SERVICE BULLETIN

N° 139-669

DATE: May 31, 2022

ATA 23 - SATCOM FLIGHTCELL DZMX ELECTRICAL VARIANT INSTALLATION

Figure 9

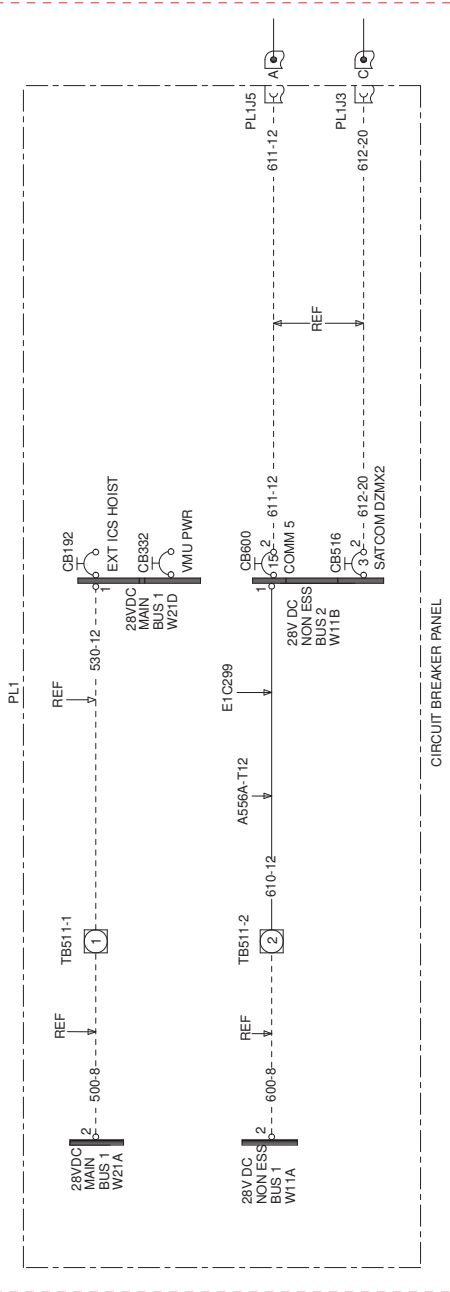
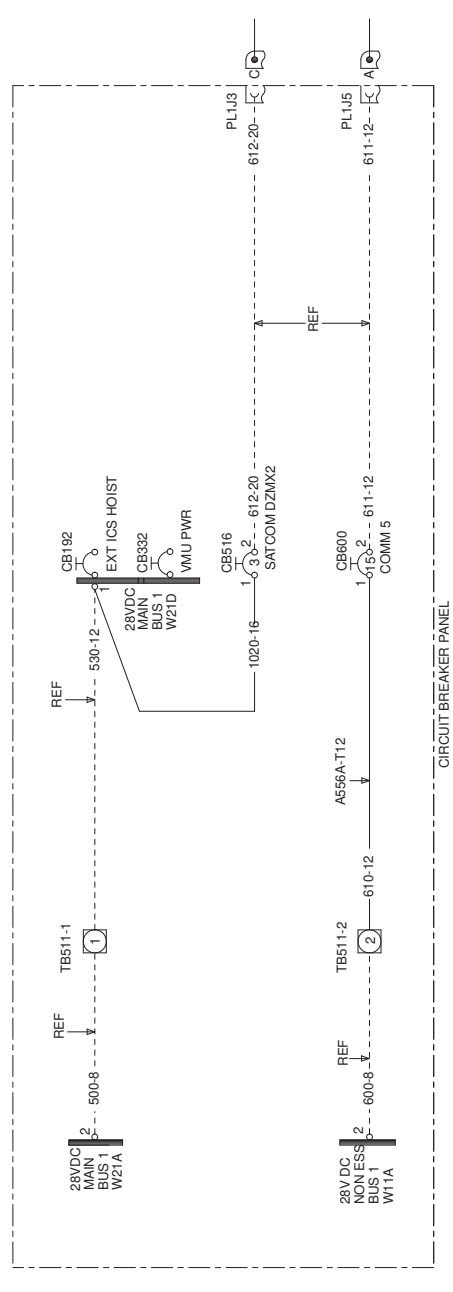
- 4.2 With reference to Figure 9 wiring diagram (WAS), disconnect, remove or stow the electrical connections as required.
 - 4.3 With reference to Figure 5 Detail A, remove bus bar P/N 1035685-22, screw P/N NAS1802-3-7, locking washer P/N MS35338-138 and washer P/N NAS1149D0332K from circuit breakers CB600 and CB516.

- 4.4 With reference to Figure 5 and Figure 9 wiring diagram (BECOMES), cut a wire P/N A556A-T16 of adequate length and lay down between circuit breaker CB516 and 28VDC main bus 1 W21D.

- 4.5 In accordance with AMP DM 39-A-20-10-08-00A-622A-A and with reference to Figure 9 wiring diagram (BECOMES), crimp on wire an electrical contact P/N MS25036-153 (CB516 side) and an electrical contact P/N MS25036-112 (W21D side) by means of proper crimping tool.

- 4.6 In accordance with AMP DM 39-A-20-10-18-00A-691A-A and with reference to Figure 9 wiring diagram (BECOMES), mark wire as 1020-16 by means of marker sleeve P/N A578A.

- 4.8 In accordance with AMP DM 39-A-20-10-08-00A-622A-A and with reference to Figure 9 wiring diagram (BECOMES), crimp on wire an electrical contact P/N MS25036-156 (CB600 side) and an electrical contact P/N MS25036-112 (TB511-2 side) by means of proper crimping tool.

- 4.9 In accordance with AMP DM 39-A-20-10-18-00A-691A-A and with reference to Figure 9 wiring diagram (BECOMES), mark wire as 610-12 by means of marker sleeve P/N A578A.

- 4.10 With reference to Figures 5 and 6 and Figure 9 wiring diagram (BECOMES), perform the electrical connections of AUX CB PNL variant C/A E1C300 between pin 1 of circuit breaker CB516 and 28VDC main bus 1 W21D and between terminal board TB511-2 and pin 1 of circuit breaker CB600.
